# Umetco Minerals Corporation

Re: Umetco Minerals Corporation  
SUA-1358: Docket No 40-8681  
White Mesa Mill, Utah  
License Condition 20

The following is the response required by URFO's letter dated June 5, 1990.

**Figure 1**

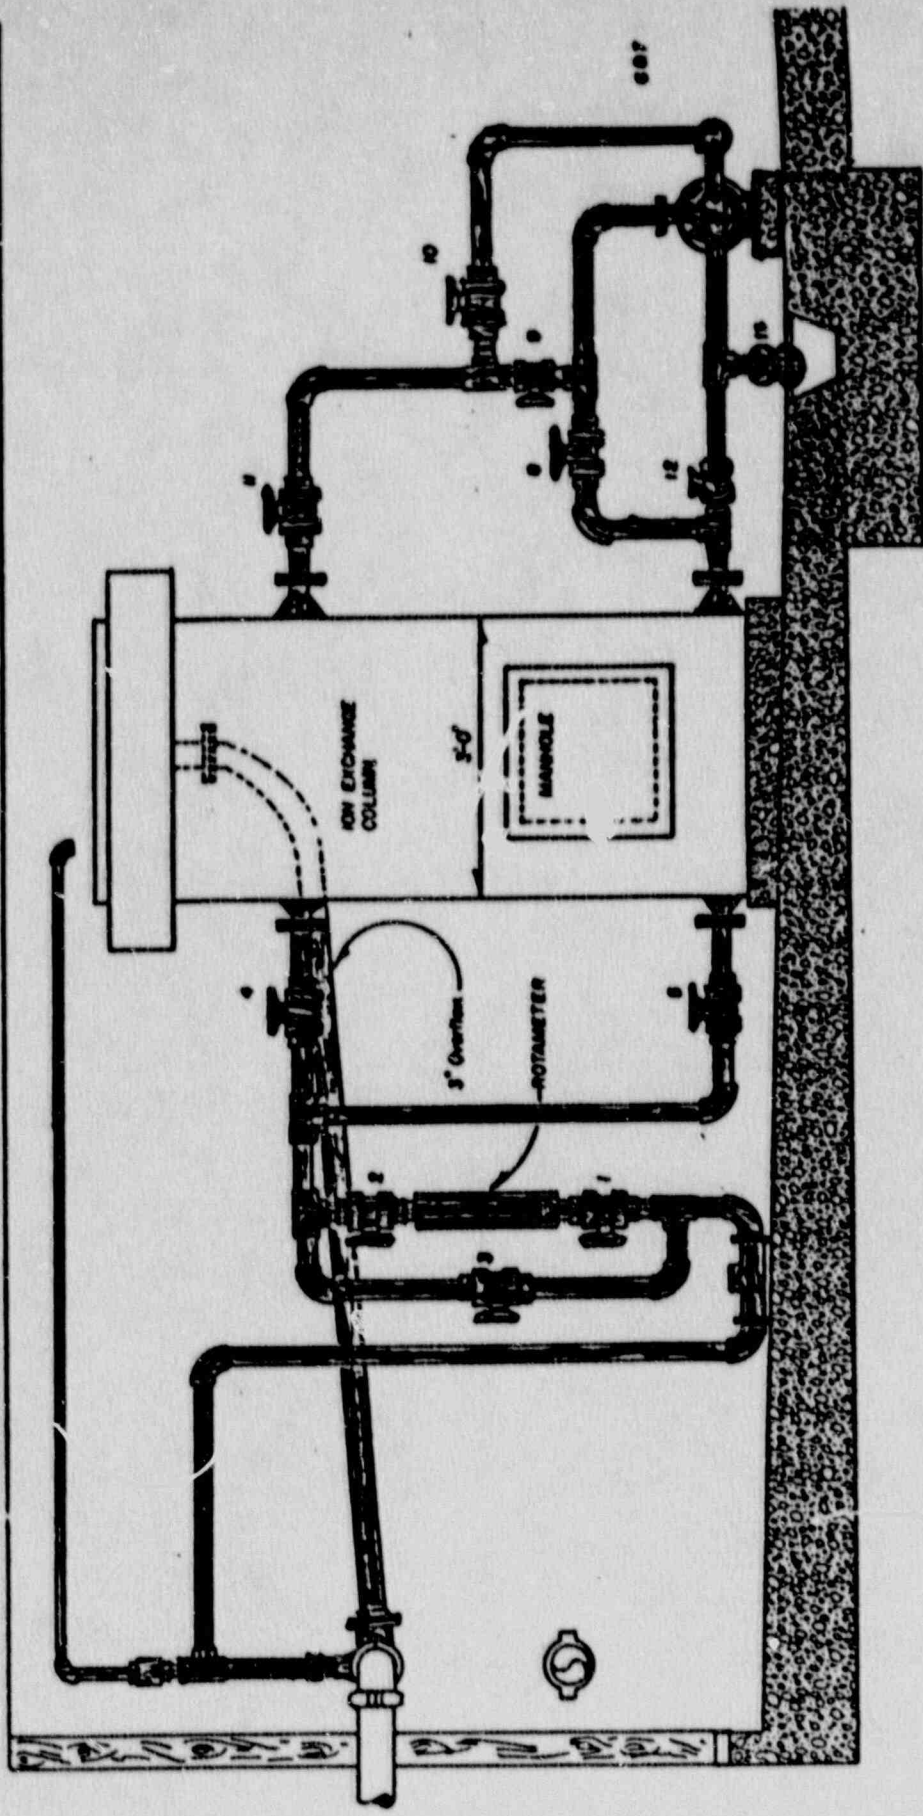
3. A cost estimate for decommissioning of the Velvet Mine IX facilities was submitted to the NRC on March 9, 1989. However, no amount was included in your revised surety calculations for the Velvet Mine IX. In addition, the cost estimates in your March 9, 1989 submittal are not adequate or of sufficient detail. A cost estimate should be prepared with similar content and detail as in your March 15, 1986, reclamation plan submittal. The basis or source of cost estimates (e.g., Means Cost Data) should be provided and amounts included for mobilization, contractor overhead and profit, and a minimum 15 percent contingency. These costs must also be adjusted to December, 1989 dollars and included in a revised total surety amount.

Response: The Velvet Mine IX takes an unlicensed uranium source (mine water), transfers uranium to resin beads (the licensed activity), and discharges unlicensed material (water stripped of uranium) to ponds. The appropriate reclamation plan will be concerned with materials and equipment covered by the licensed activity. In the case of the Velvet Mine IX, the reclamation plan

must estimate the costs associated with equipment removal and/or disposal at a licensed facility, and the decontamination of the area in which the equipment and materials were located.

The Velvet Mine IX column consists of piping, a pump, and a column filled with approximately 40 cubic feet of resin beads. See Figure 1. The piping is made of PVC and the column is made of FRP. Dismantling the piping, pump, installing blanks on column fittings, and loading all materials for shipping to the White Mesa Mill will take 2 men 2 days. Air samples for radon-222 and airborne uranium would be taken during dismantling. The samples may be personal or area.
